Assessment of Dam Safety Coal Combustion Surface Impoundments (Task 3) Final Report

Kentucky Utilities

Ghent Generating Station

CHA Project No. 20085.2030.1510

GYPSUM STACKING FACILITY TYPICAL CROSS SECTION AND STABILITY ANALYSIS
 GHENT GENERATING STATION
 GHENT, KENTUCKY

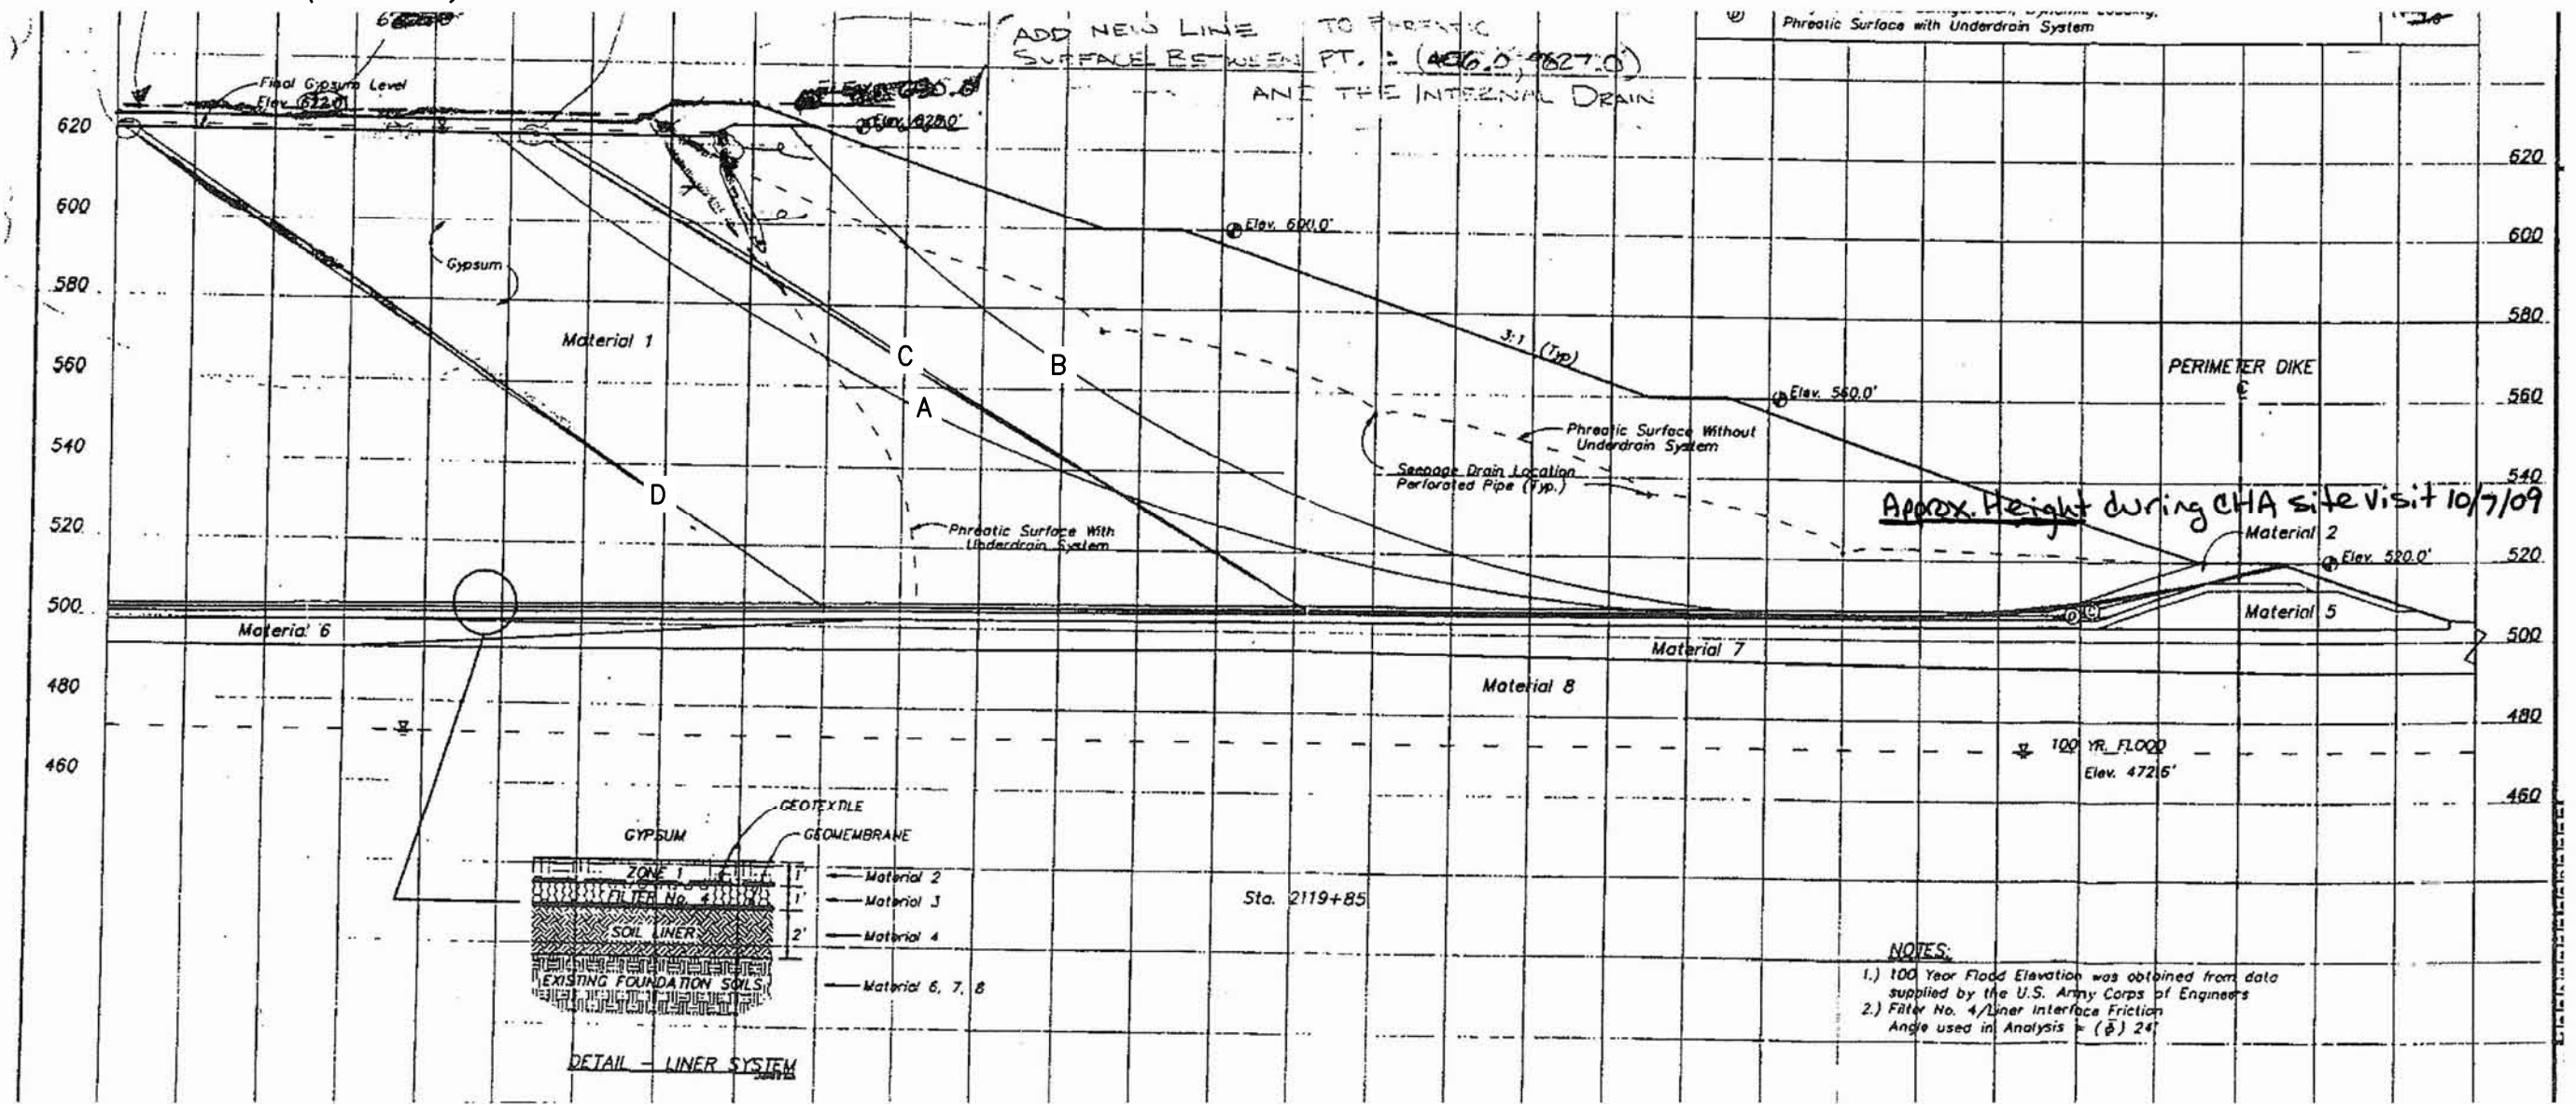
FMSM reported that control of the phreatic surface within the stacked gypsum is critical to the stability of the facility. Therefore, not only is there an underdrain system in the bottom of the pond, but periodic seepage drains are scheduled to be installed at various elevations as the gypsum is stacked. In addition, a supplemental drainage layer has been designed and is being added. These seepage drains are intended to act as a backup in case the underdrain system and supplemental drain fails. Figure 6 (in Section 1) shows the stability analysis results and

FIGURE 10A

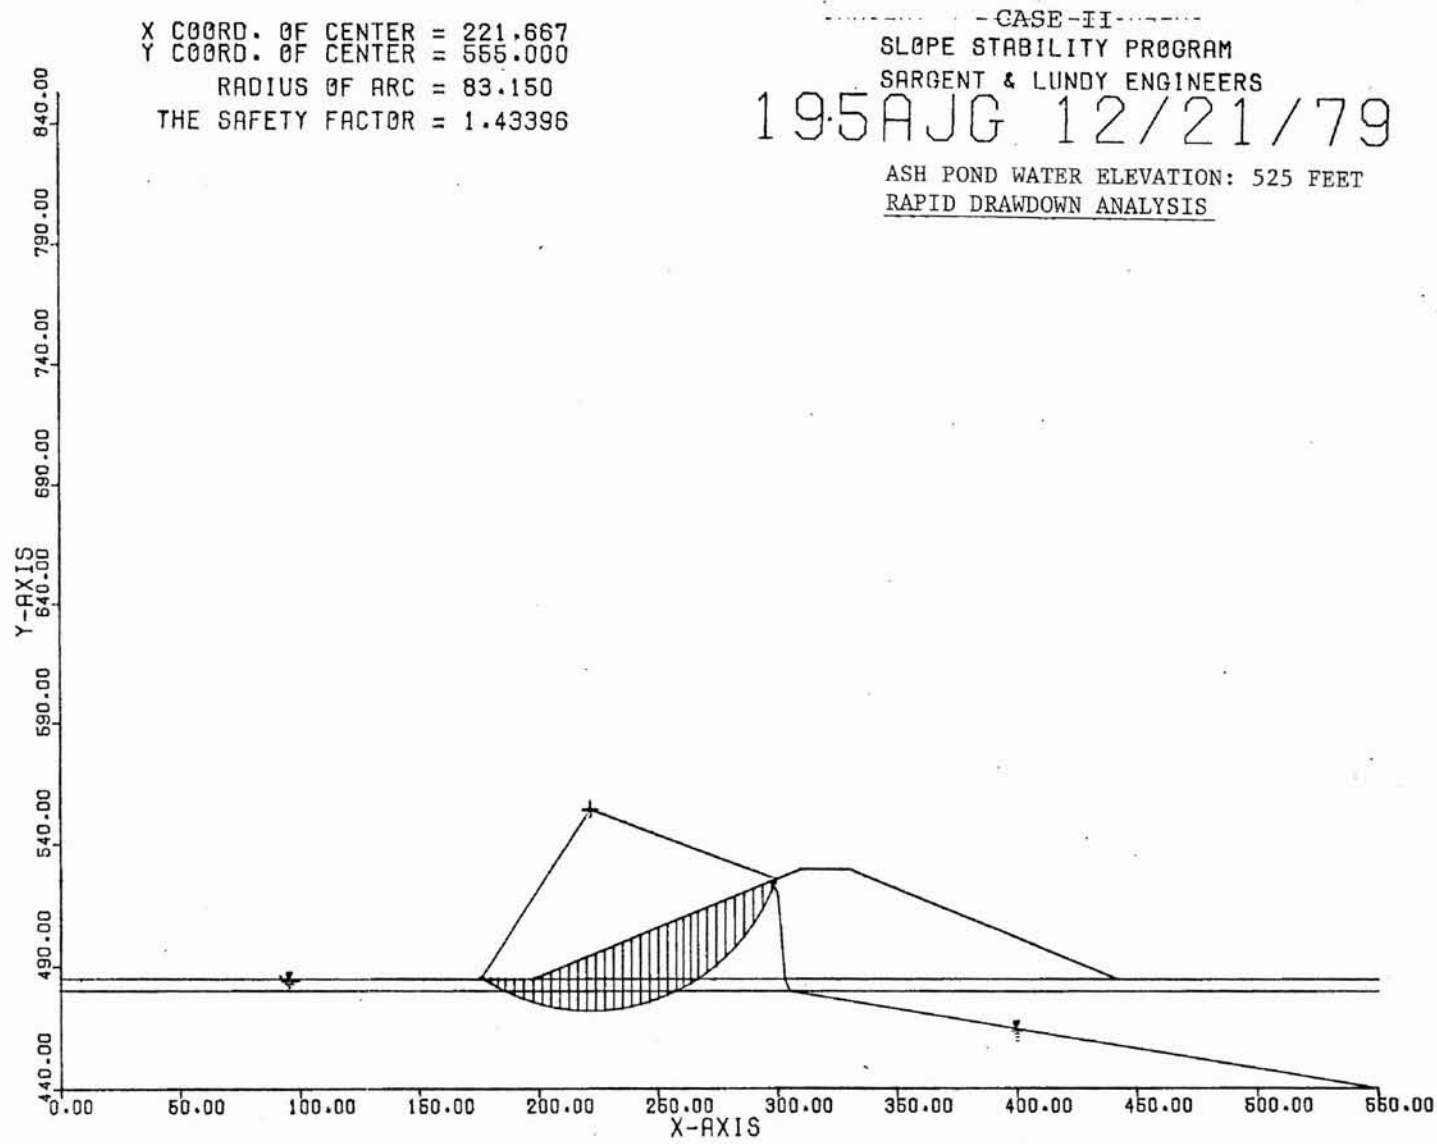
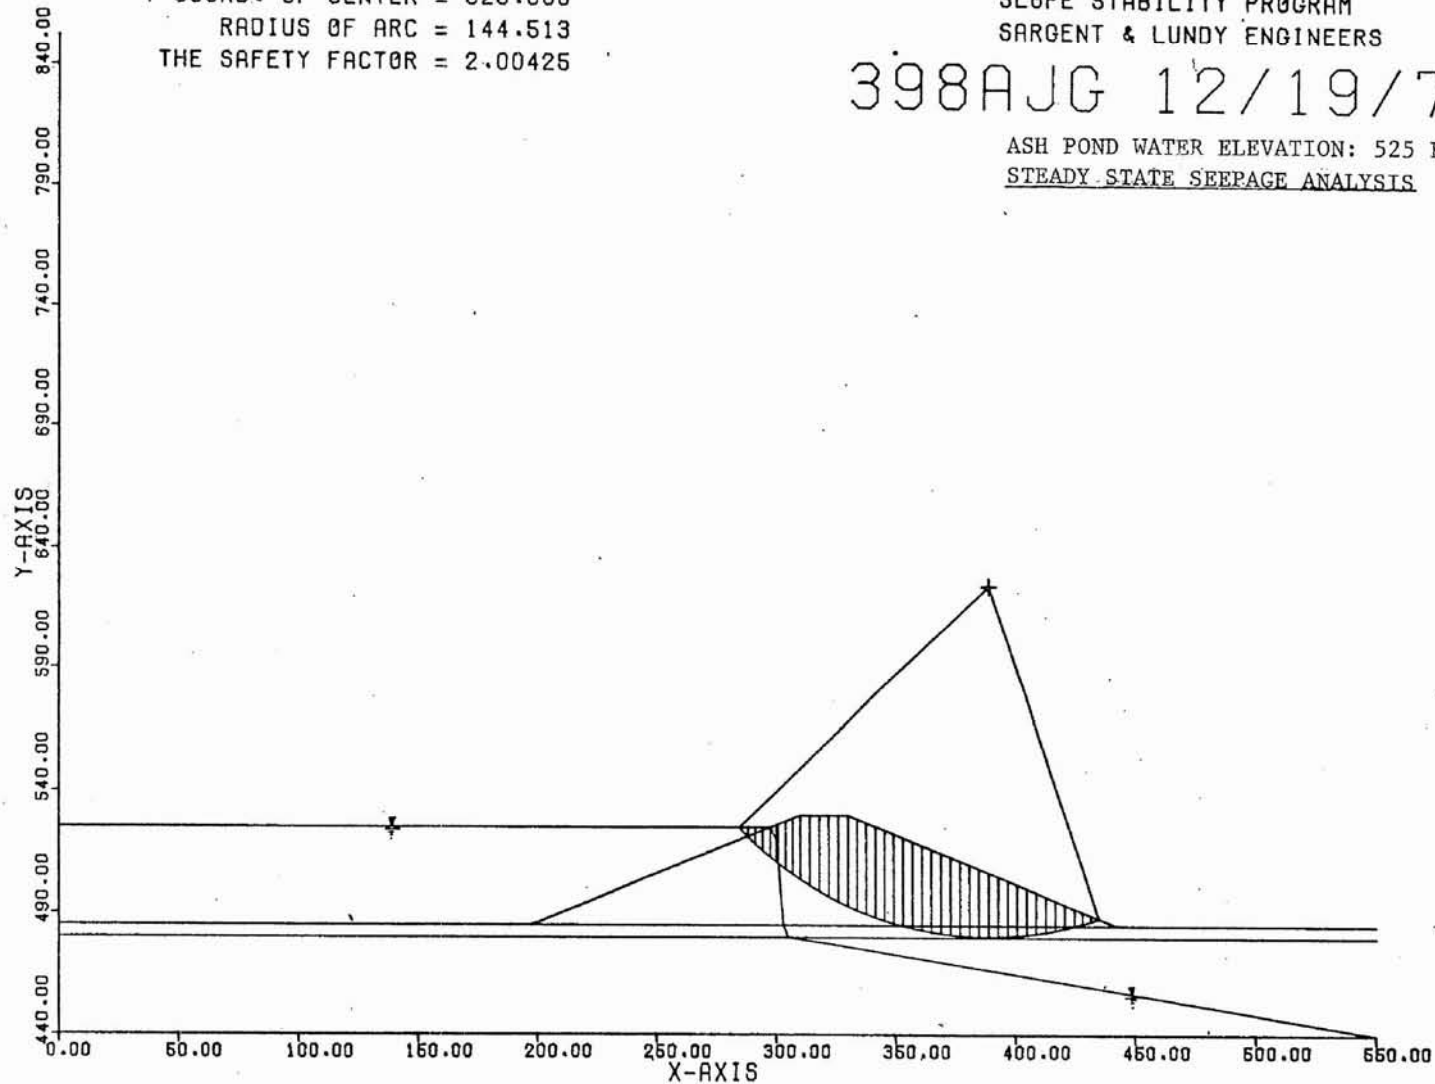
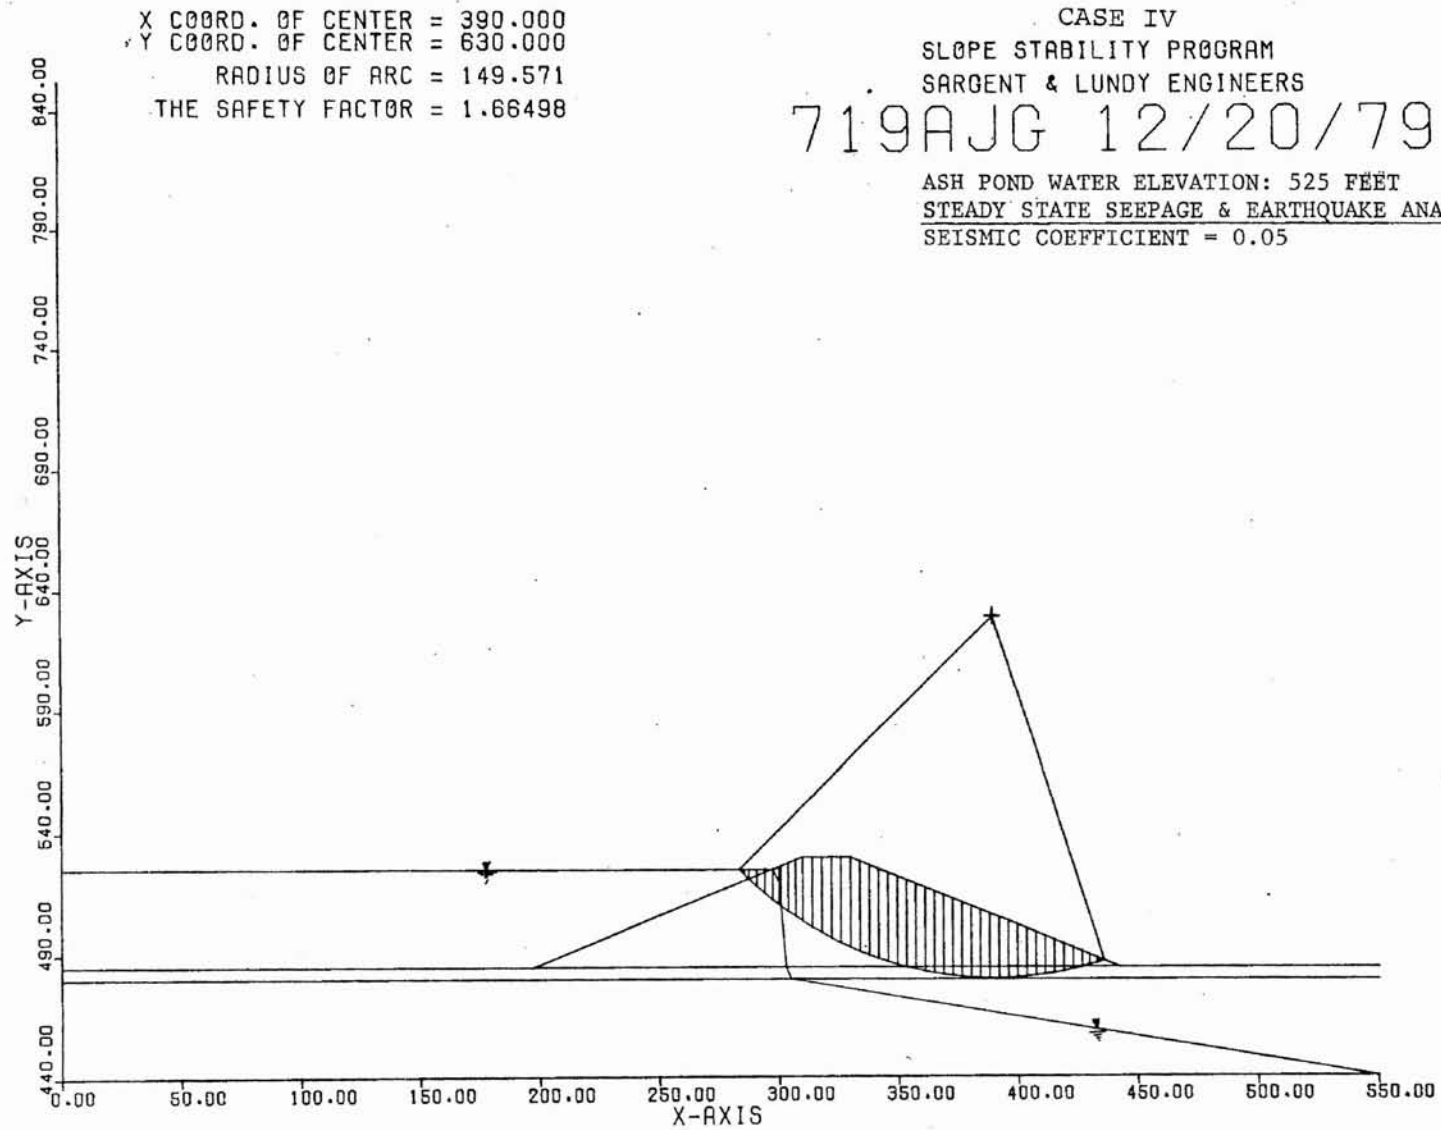
For the typical sections of the embankment (west and north sides of the impoundment) the Sargent & Lundy analyses resulted in the factors of safety summarized in Table 7. Figures 10a, 10b, and 10c show the stability analysis cross sections.

PROJECT NO.
20085.2030
 DATE: 12/2009
 FIGURE 11

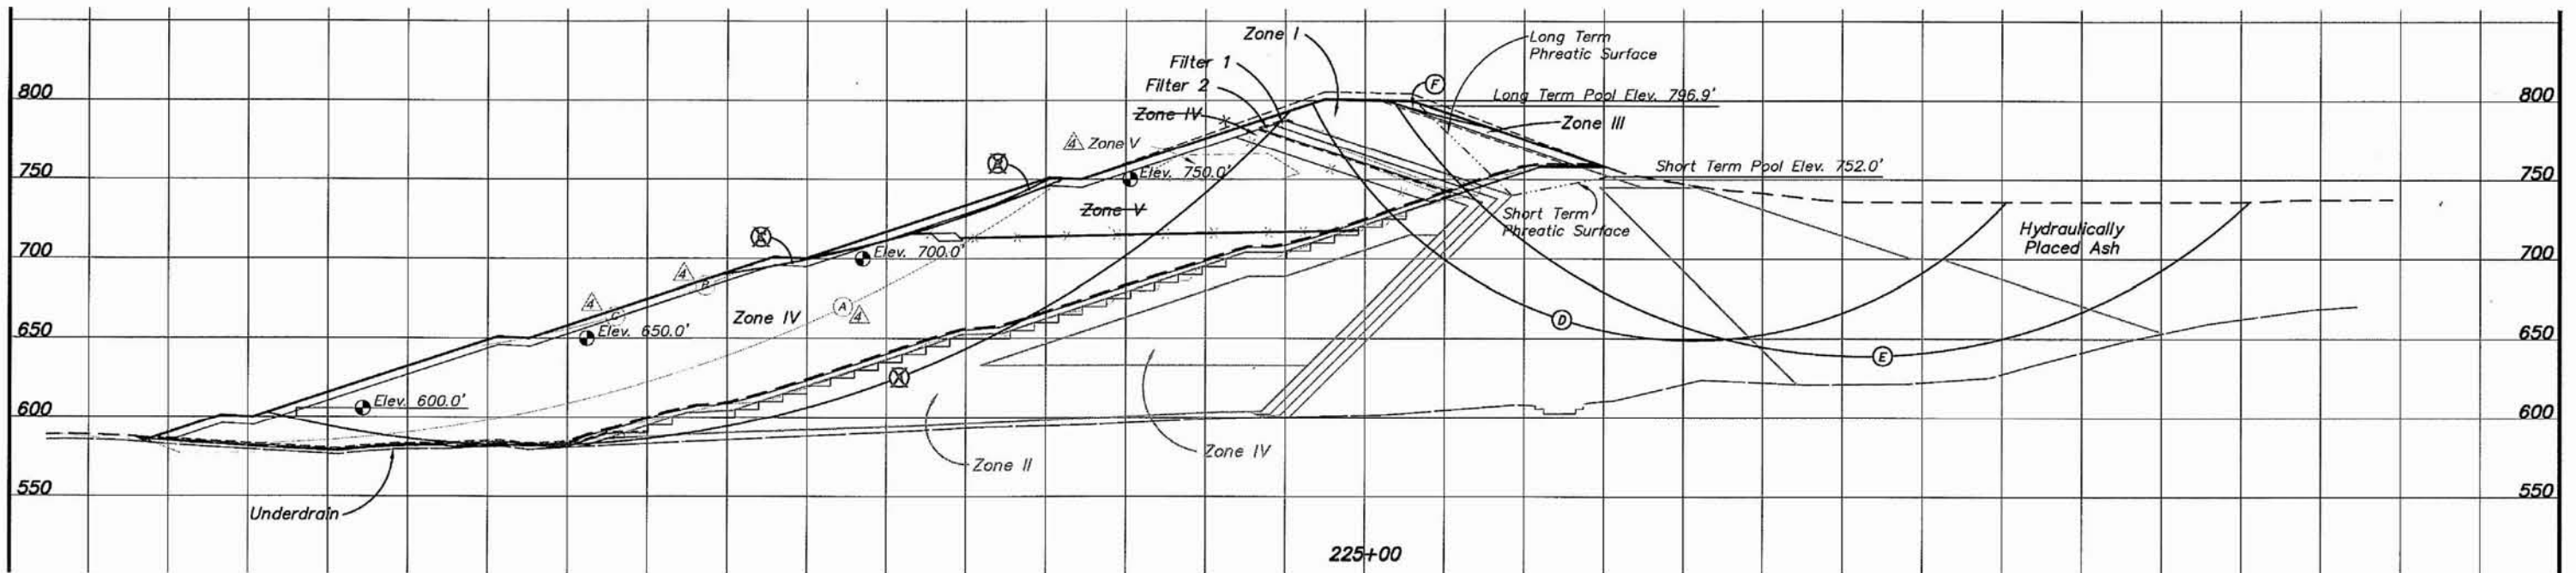
CHA was provided with the Engineering Design Report for the raising of ATB #2 as well as record drawings showing the actual placement of zoned material in the embankment. Figure 11 was taken from the record drawings and shows the stability analyses and zones of materials used for the embankment construction. Table 9 summarizes the soil properties used for steady state conditions in analyzing the embankment. Descriptions of the soils represented by zone numbers were taken from technical specs provided in the Engineering Design Report.
